RE: 45 Day Letter Response
AI Number: **179399**
Tidal Wetlands License Application Number: **23-WL-0813**
US Wind, Inc. Operations & Maintenance Facility – Pier Installation

This letter is in response to your email, dated October 20, 2023, requesting additional information to complete the application for US Wind, Inc.'s Operations & Maintenance Facility – Pier Installation. The responses to comments are provided below.

Attachment 2 – Revised Impact Plates

CONCEPTUAL FIXED PIER SECTION A-A

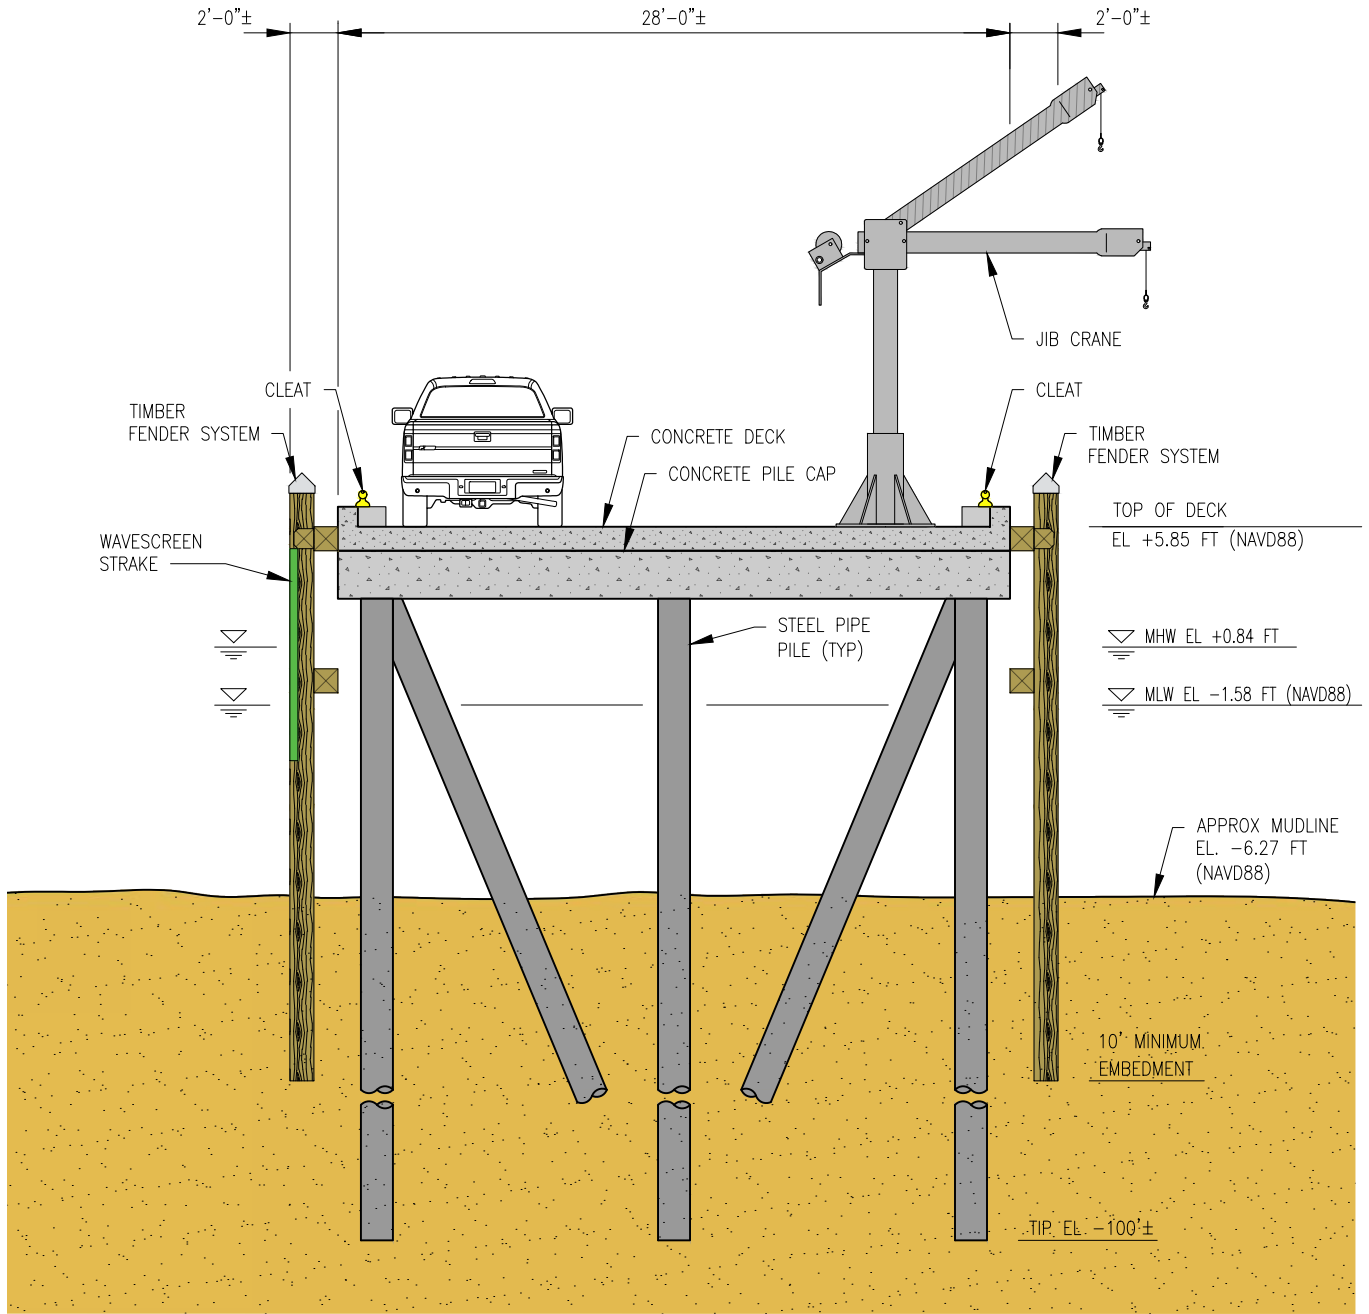
3. Comment: *Additional justification for the proposed pier dimensions. The cross-section shows a full-size truck and crane. Why does the pier need to be 28 feet wide? Is this to allow for enough space for two trucks to pass? Will materials used in the development of offshore wind facilities be loaded/unloaded on the pier? Is there a maximum load this pier have been designed to accommodate? Purpose and need should be elaborated upon.*

7. Comment: *Plan cross-section should include the MLWL and MHWL. Include the reference tidal station in the plans.*

Response: The pier is intended to be built in a continuous straight line beginning with the bulkhead at the north-westernmost corner of the property and continuing to the east for up to 800 feet. This will allow vessels to moor up alongside the pier without having to account for a jog in the pier. In order to maintain this continuous pierface while allowing for the pier to remain connected to the original footprint of the current dilapidated pier, the width of the pier is 28 feet. The width is not intended for two trucks to pass on the pier, but the pier will potentially be used to support a single vehicle such as a 1- ton flatbed truck to transfer personnel, parts, and equipment from the warehouse and a mobile crane to load and offload these items onto and off of the crew transfer vessels. Based on the current design, the maximum load of the pier will be approximately 500 psf.

Response: The plan cross-sections have been revised to include the MLWL and MHWL, included in the revised impact plates in **Attachment 2**.

CONCEPTUAL FIXED PIER SECTION B-B

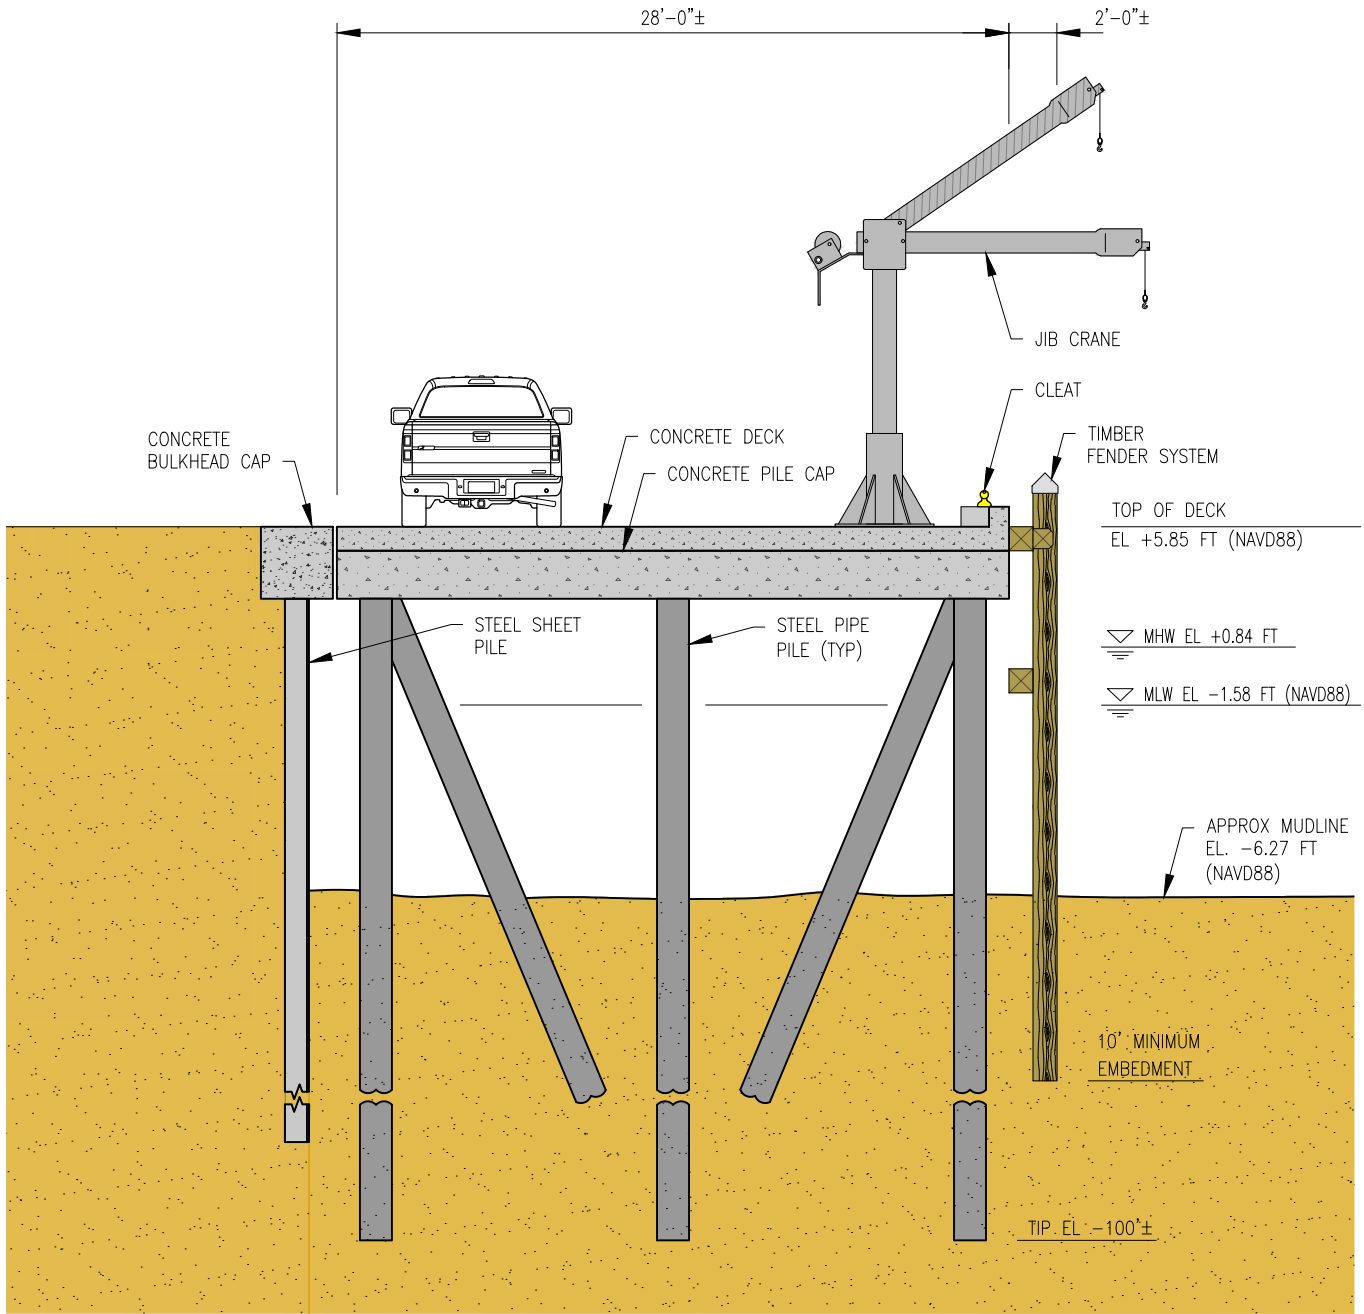
2. Comment: *Does the fender system and wavebreak need to be embedded into the substrate? Wavebreaks need to be a minimum of 6 inches, preferably 2 feet, above the substrate to allow for the passage of aquatic life. As designed, the wavebreak might act more as a breakwater/jetty, potentially impacting nearshore sediment movement and impacting aquatic life. Plate 06 of 08 shows the wavescreen strake and it appears that this cross-section shows it terminating below MLLW free of the mudline. Is this correct? Can you provide some additional information on the need for the wavebreak?*

An additional cross-section of the timber fender system and wave break from its broadside would be helpful to show that it isn't a continuous structure, almost like a second bulkhead. It might be that the timber fender system consists of piles every 10 or so feet apart and wave breaks are not embedded in the substrate, however, I can not see this in the plans.

Response: The wavescreen strake will be located within the water column only and will not be embedded in the substrate. To clarify this, US Wind has revised the impact plates to show the wavescreen strake in green to distinguish it (see Plate 6). An additional cross-section of the timber fender system and wave break has also been included on Plate 9. Revised impact plates are included in **Attachment 2**.
